Subject: Callaway Plant, Unit 1 - Amendment No. 12 to License NPF-30

AMENDMENT TO FACILITY OPERATING LICENSE

Amendment No. 12  
License No. NPF-30

SUPPORTING AMENDMENT NO. 12 TO OPERATING LICENSE NO. NPF-30

FIGURE 3.9-1

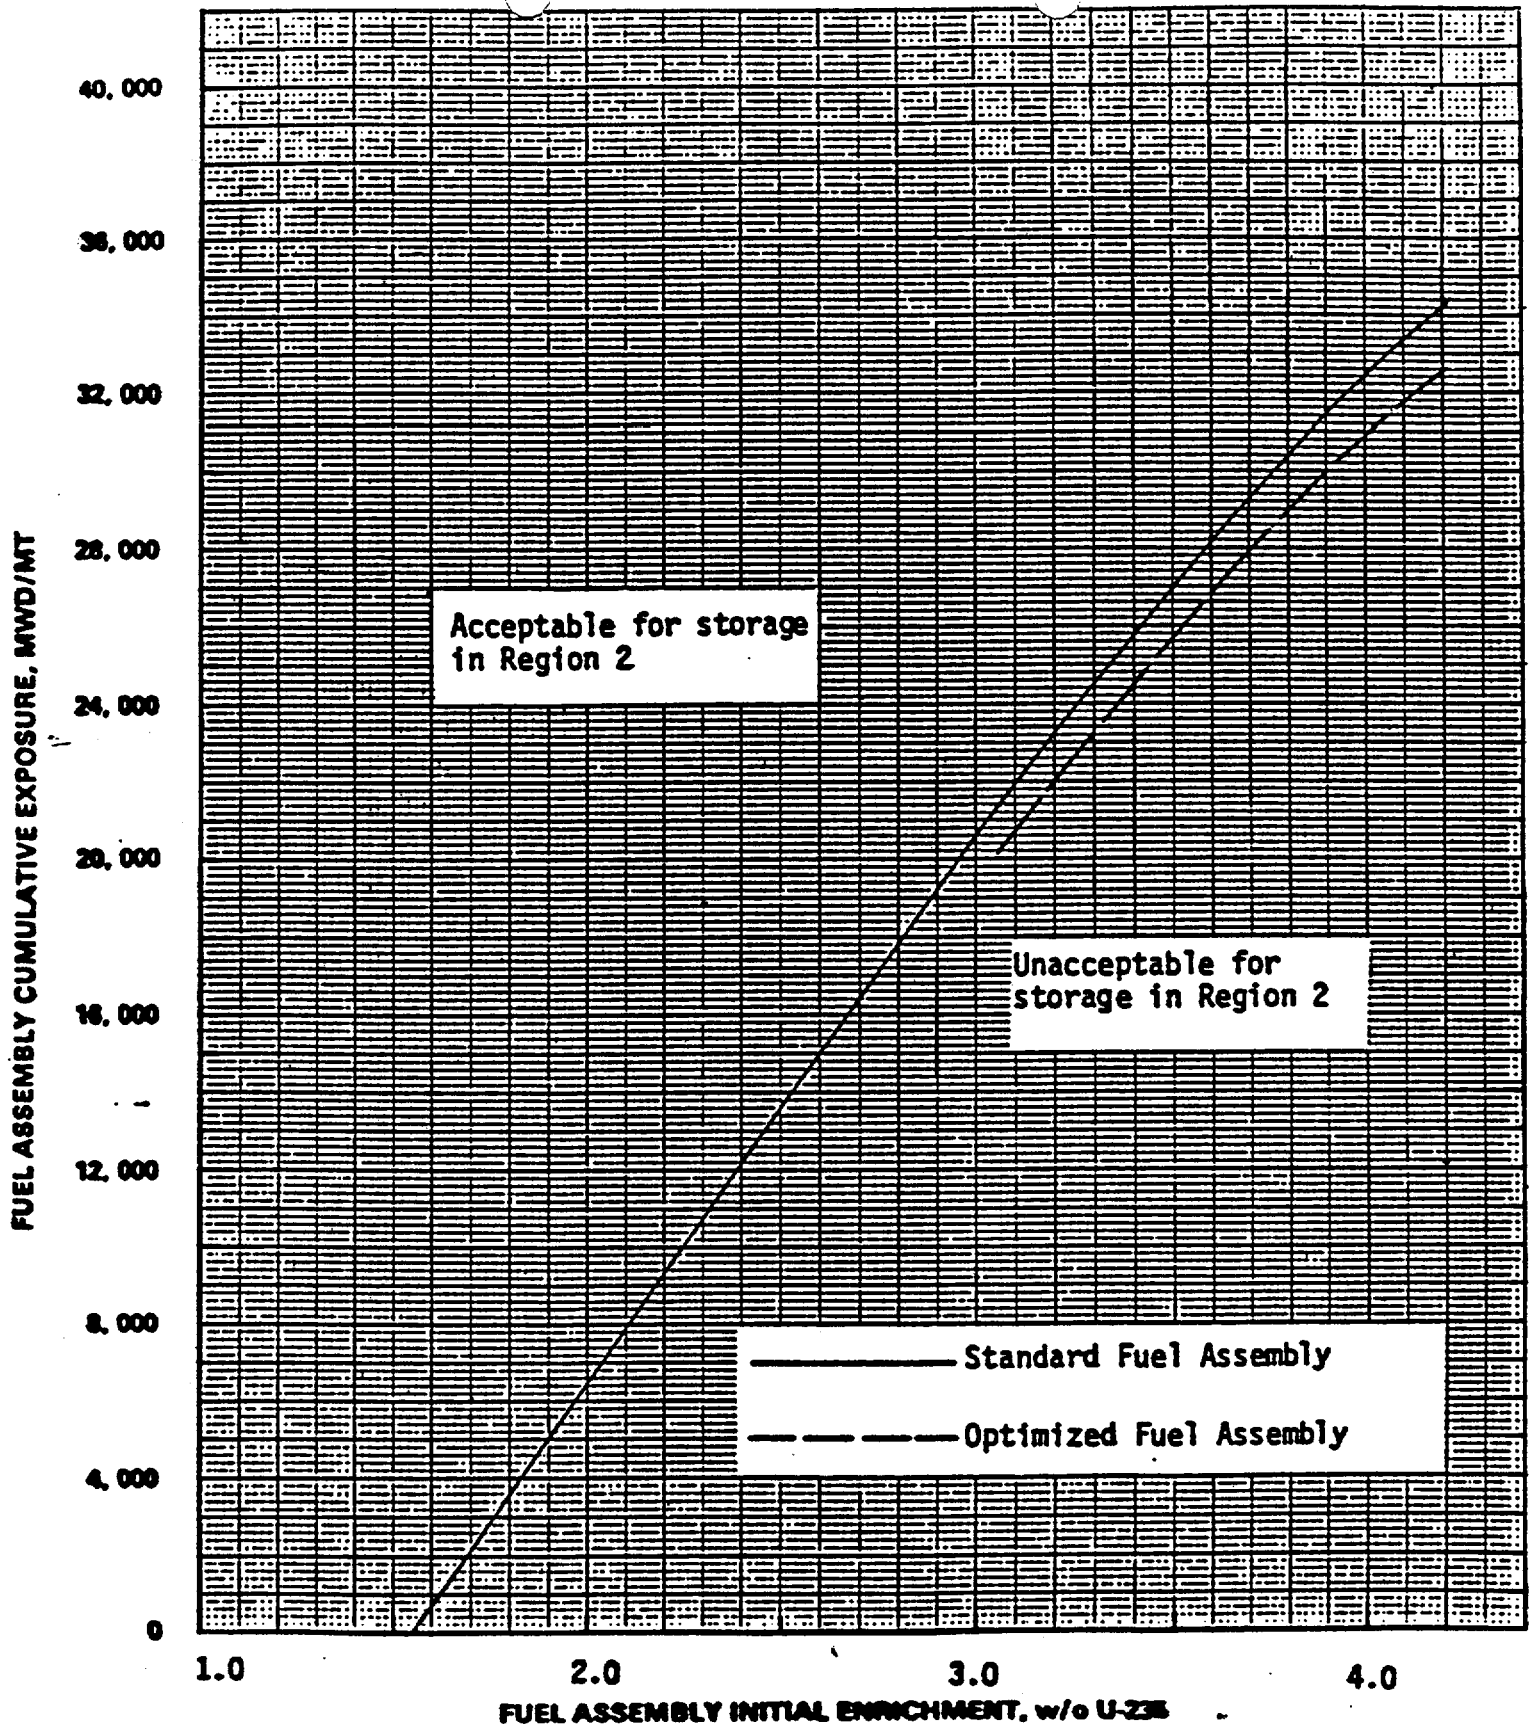
The amendment approves modifications to Pages 3/4 9-16, 5-6 and 5-7, and the amendment approves deletion of Page 5-8 of the Callaway Technical Specifications (TS). The amendment increases the permitted enrichment for storage in the Callaway Plant, Unit 1 spent fuel storage pool from the current value of 3.5 weight percent (w/o) U-235 to 4.2 w/o. This permits extended cycle operation in the Callaway plant and results in larger discharge fuel burnups. Therefore, the curve of acceptable burnup as a function of initial enrichment (Figure 5.6-1 in the present Technical Specifications) is extended. This figure is also amended to include a separate curve for the optimized fuel assembly.

Figure 3.9-1 of Technical Specification 3/4.9.12 is altered to account for the revised analyses and to include a curve for OFA fuel. The revised curves are consistent with the analyses and are acceptable. Specification 5.3.1 is revised to increase the permitted enrichment in the core to 4.2 w/o U-235. This is consistent with the limit for the spent fuel pool and is acceptable.
